RE: **Reflective Auto Collision**  
**801 Gibson Blvd SE**  
**Grading Plan Stamp Date: 7/15/19**  
**Hydrology File: L14D061**

Based on the submittal received on 7/16/19, the grading plan cannot be approved until the following corrections are made:

**GRADING AND DRAINAGE PLAN**

**A PROPOSED PLAN  
FOR  
REFLECTIVE AUTO COLLISION**  
801 GIBSON BOULEVARD S.E.  
ALBUQUERQUE, NEW MEXICO

**WASTE WATER HARVESTING POND (NOT TO SCALE)**

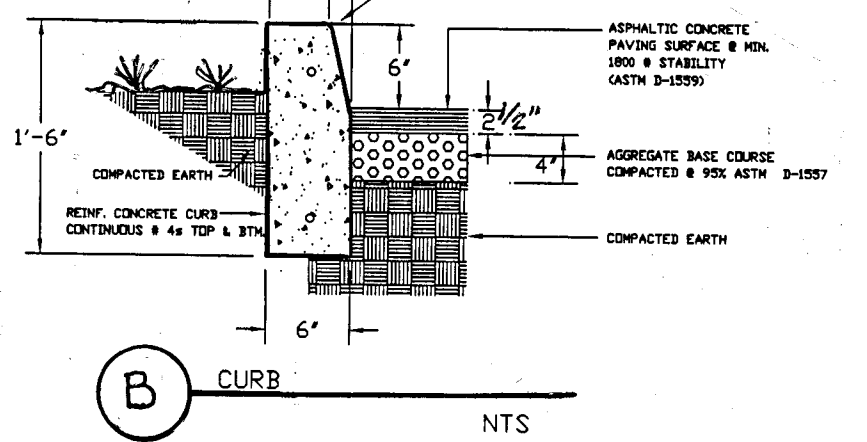
10. Provide the weir calculations, per DPM Chapter 22.3.A.1, for the curb cuts. A coefficient of 2.7 is typically used for the weir equation  $Q = CLH^{2/3}$ .
11. How will the pond discharge to the public ROW?
12. The as-built size of the retaining wall does not appear to match you plan; please confirm and correct the limits of the new retaining wall.
13. Provide a waterblock on the Gibson entrance to ensure onsite flows are routed into the Stormwater Quality (SWQ) pond.
14. Label the pond with the SWQV and elevation, the 100-year volume and elevation, the peak 100 year inflow and outflow, the spillway crest elevation, and the spillway flow depth.
15. For automotive repair centers, demonstrate *control of oil from vehicle parking areas* per DPM Chapter 22.9.E, Table 1.

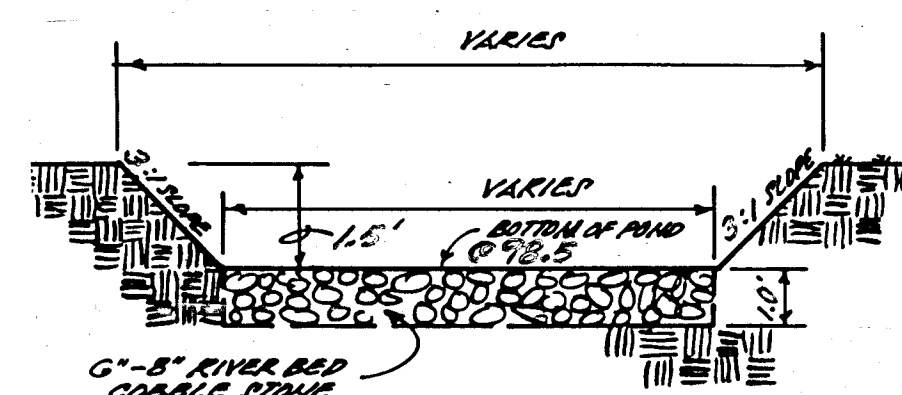
1. Use the [current DTIS version](#) (11/2018) when resubmitting.
2. Include project benchmark and datum.
3. Provide an engineer's stamp with a signature and date. Do not white-out and reuse a stamp from a previous plan.

4. The grading and drainage plan must identify and quantify all offsite flows as they pertain to these two parcels and their frontage.
5. Show the frontage improvements for any drainage infrastructure identified. All frontage improvements must be designed to current City standards.

6. Provide an armored conveyance (concrete or asphalt) to allow storm water to drain into the inlets at Walter and Ross Street.
7. Identify flow and flow bypass in the 16' alley. Any flow that bypasses the angled inlet in the alley needs to be conveyed to Ross on an armored surface.

8. The grading and drainage plan must identify and quantify all onsite flows, existing and proposed, as they pertain to these two parcels; information is missing for Lot 2-A-2.

9. The site must demonstrate adequate downstream capacity per § 14-5-2-12(G) of the Albuquerque Code of Ordinances.
